Attention: Lisa Thorne
 Company: on behalf of Mackenzie District Council
 Date: 23/05/2024
 From: Yvonne Pfluger, Partner, Landscape Planner
 Message Ref: Response to Rebuttal on PC23 (Re-zoning requests only)
 Project No: BM200372C

Mackenzie Properties Ltd (PC23.33)	Rezoning of land between Lake Ruataniwha/Pukaki Canal/ Max Smith Drive to Rural Lifestyle Zoning.
--	---	--

Figure from Mr Smith's rebuttal evidence (dated 15/05/2024), page 3

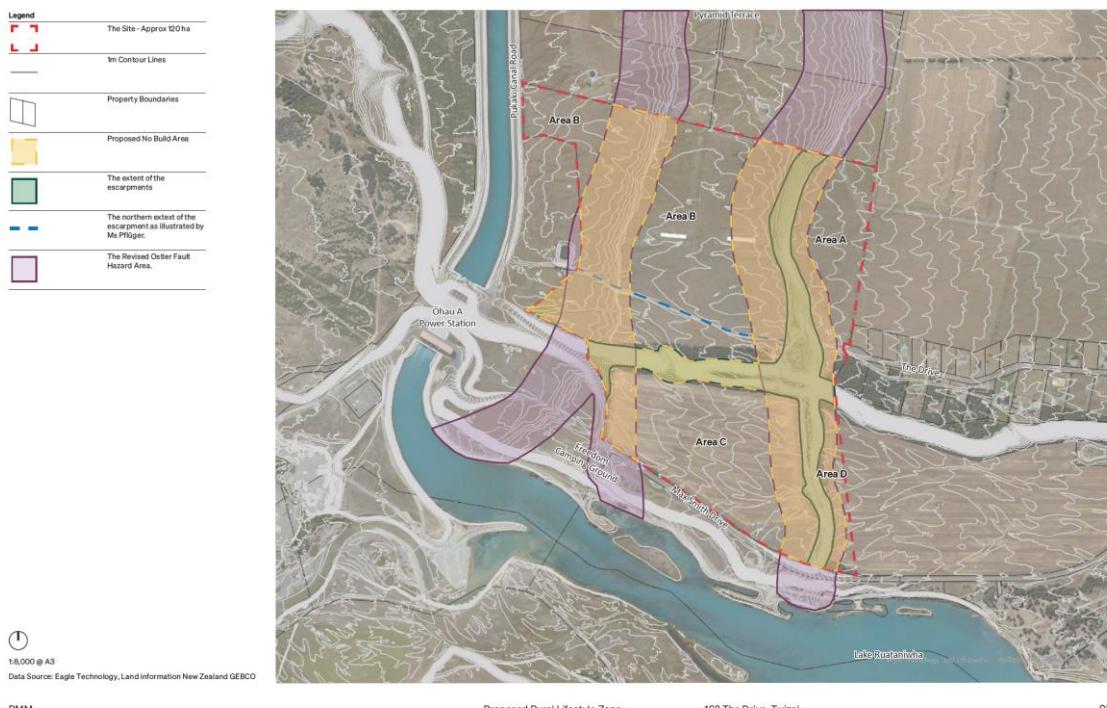
5. This additional information clearly shows the change in terrain and the location of escarpments. Based on this additional evidence, I agree with Mr Smith regarding the location of the escarpment (shown in green outline below), and support his statement (para 10 rebuttal): *"I disagree with the extent of the escarpment separating Areas B and C. This is because the area illustrated by Ms Pflüger includes a 9.2ha triangular shaped terrace that varies in width between 30 and 150m, and a small 2m tall escarpment that forms part of the northern terrace, and is not a steep landform."*

6. In order to provide consistency in labelling, I refer to the areas outlined in Mr Smith's figure above. My view in relation to the landscape and visual effect findings has not changed since the preparation of my response dated 03/05/2024. As stated previously, I consider that RLZ in Areas A and D would have low landscape and visual effects given the existing adjacent zoning. Extending the zoning into these flat areas would provide legible geomorphological boundaries along the identified escarpments.
